CITY OF PINOLE

ADDENDUM 3 **SS-2201 SANITARY SEWER REHABILITATION PROJECT (PHASE 1)** **CIP PROJECT NO. SS-2201**

October 30, 2023

3 CCCSD STD DETAIL 20-01
- NOT TO SCALE

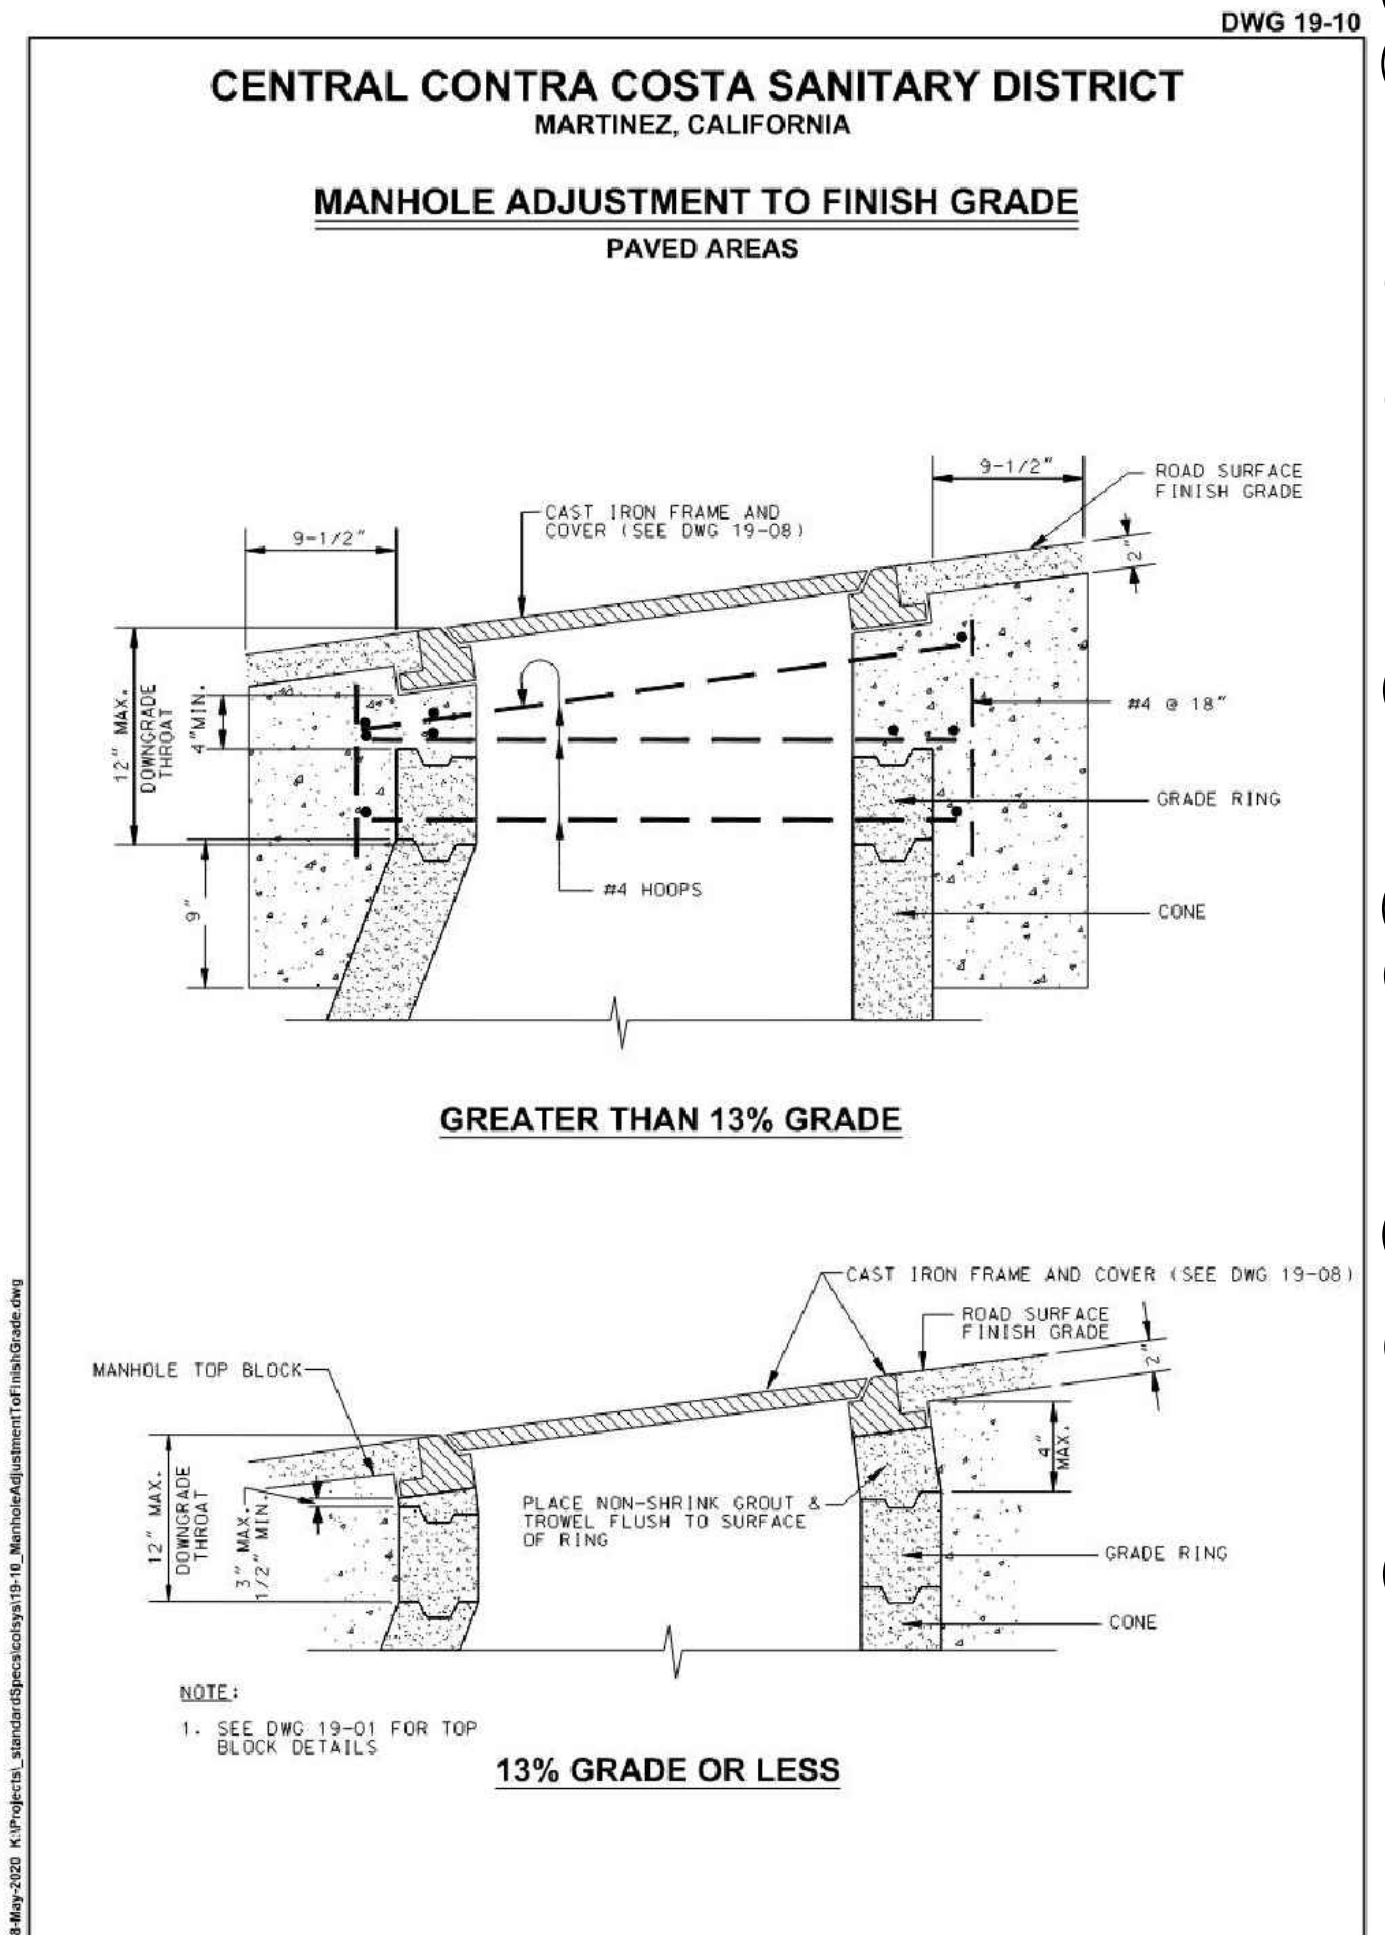
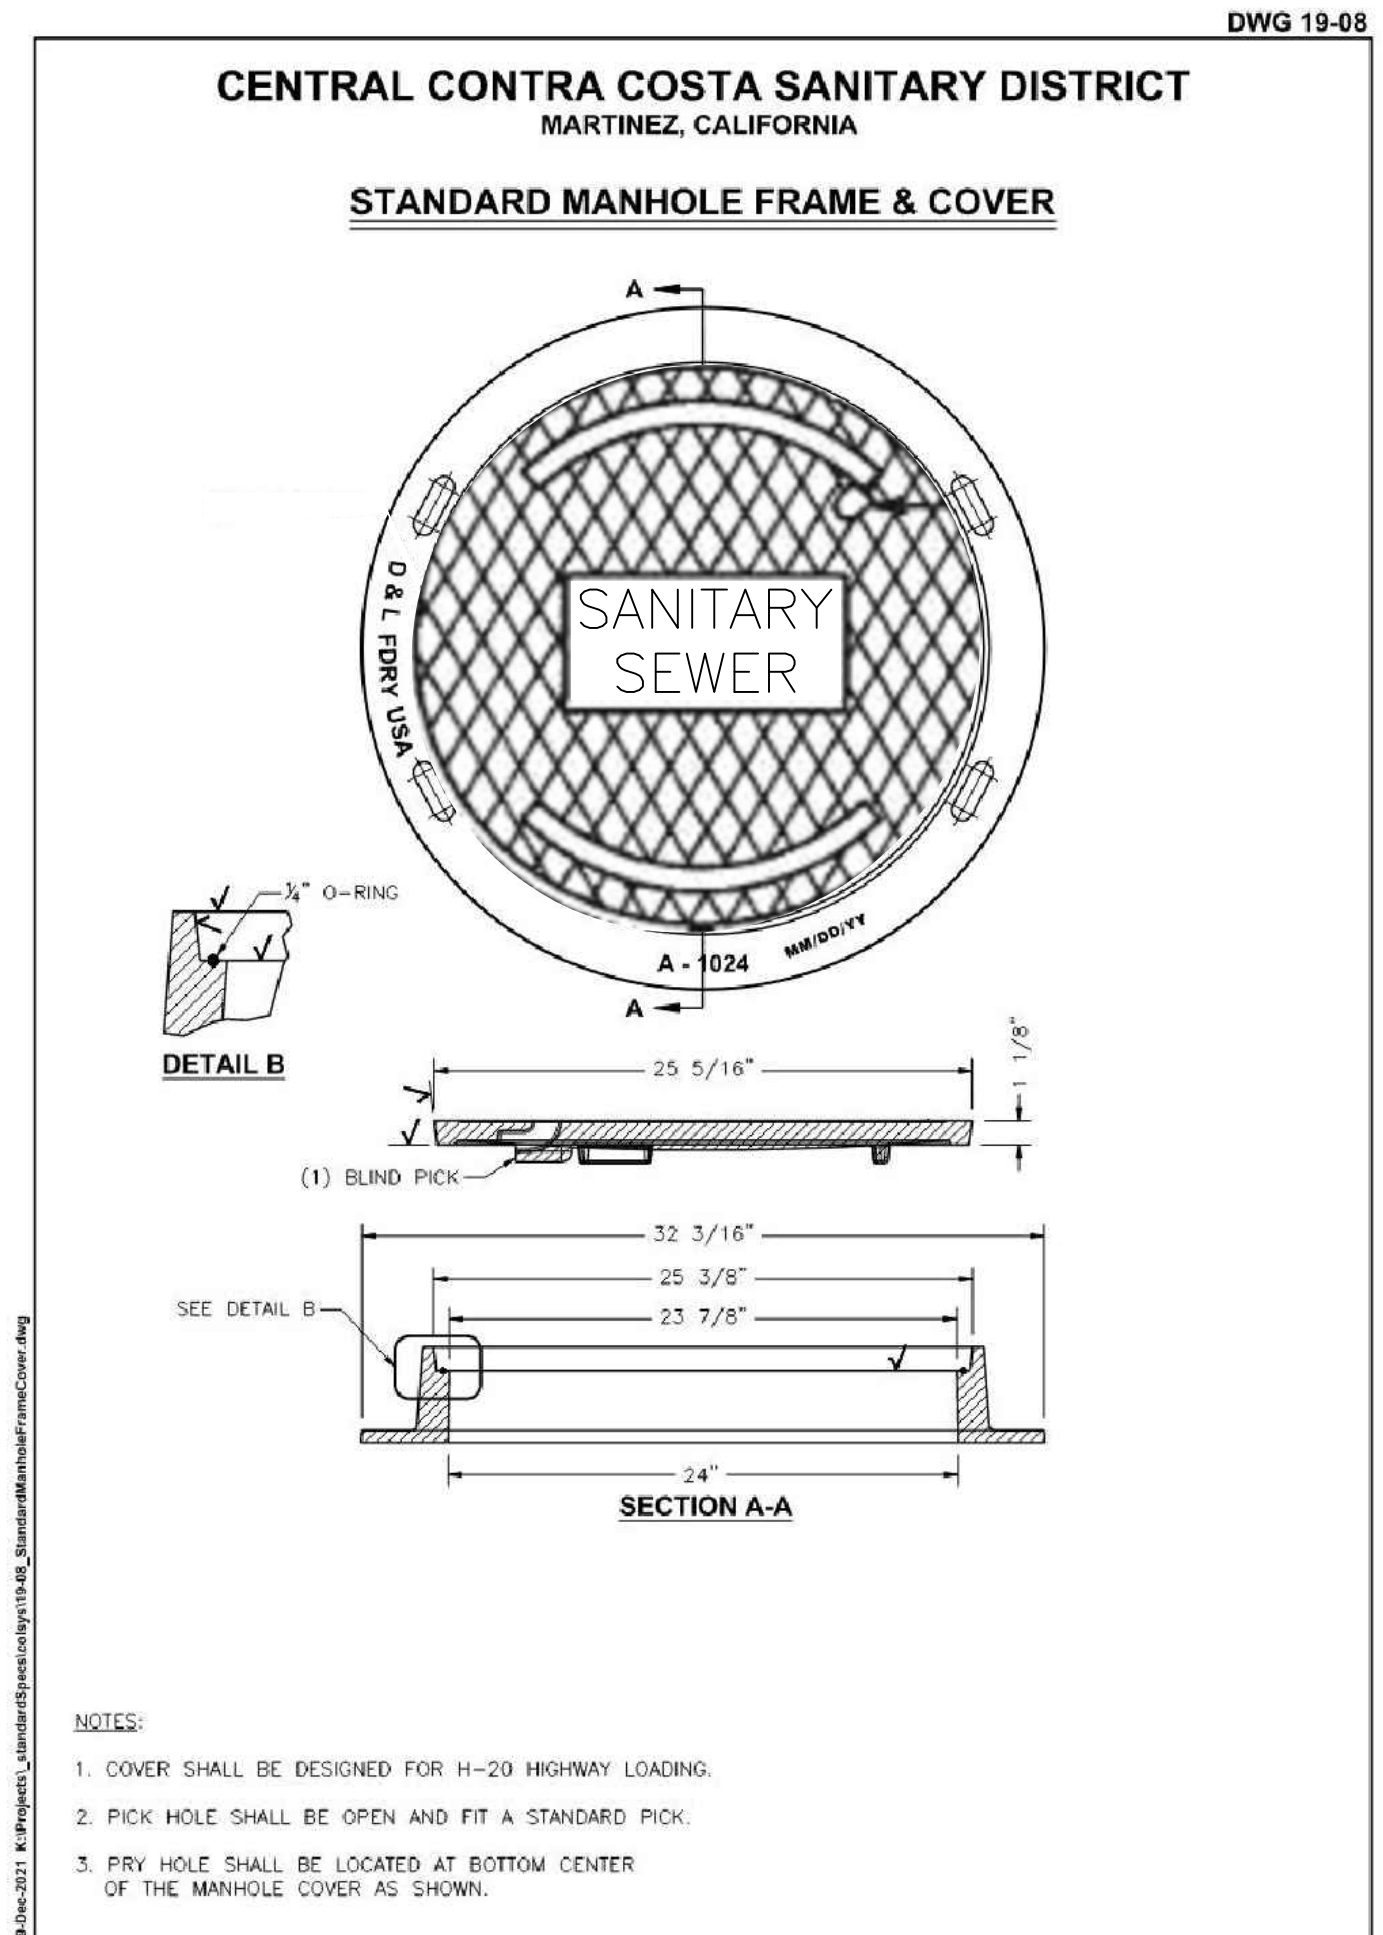
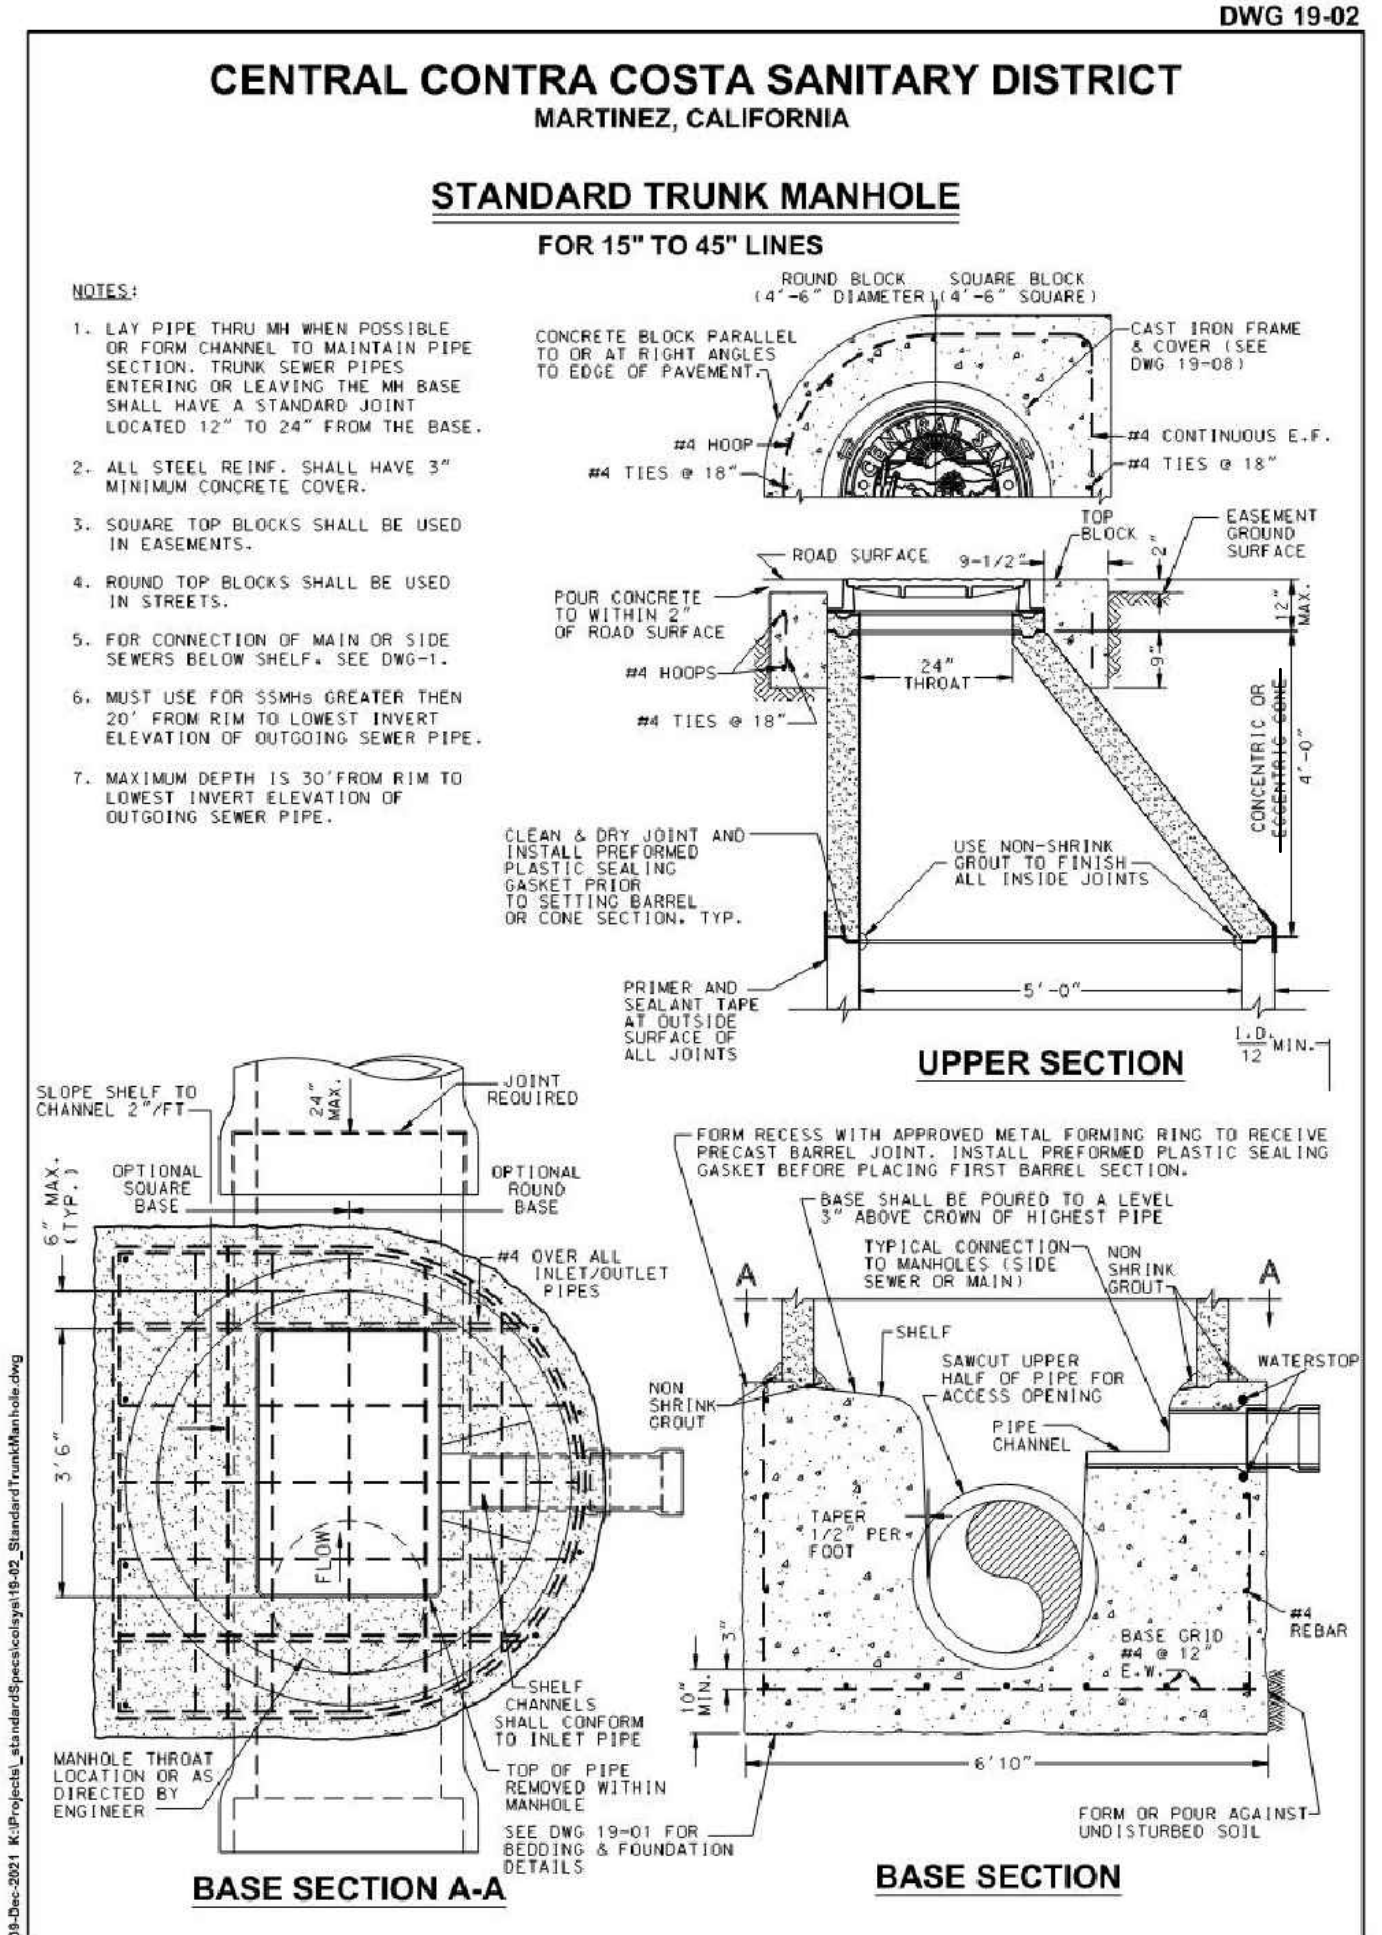
10/30/23	DCW	REVISED DETAIL 3, ADDED DETAIL 5							
NO.	DATE	BY	DESCRIPTION
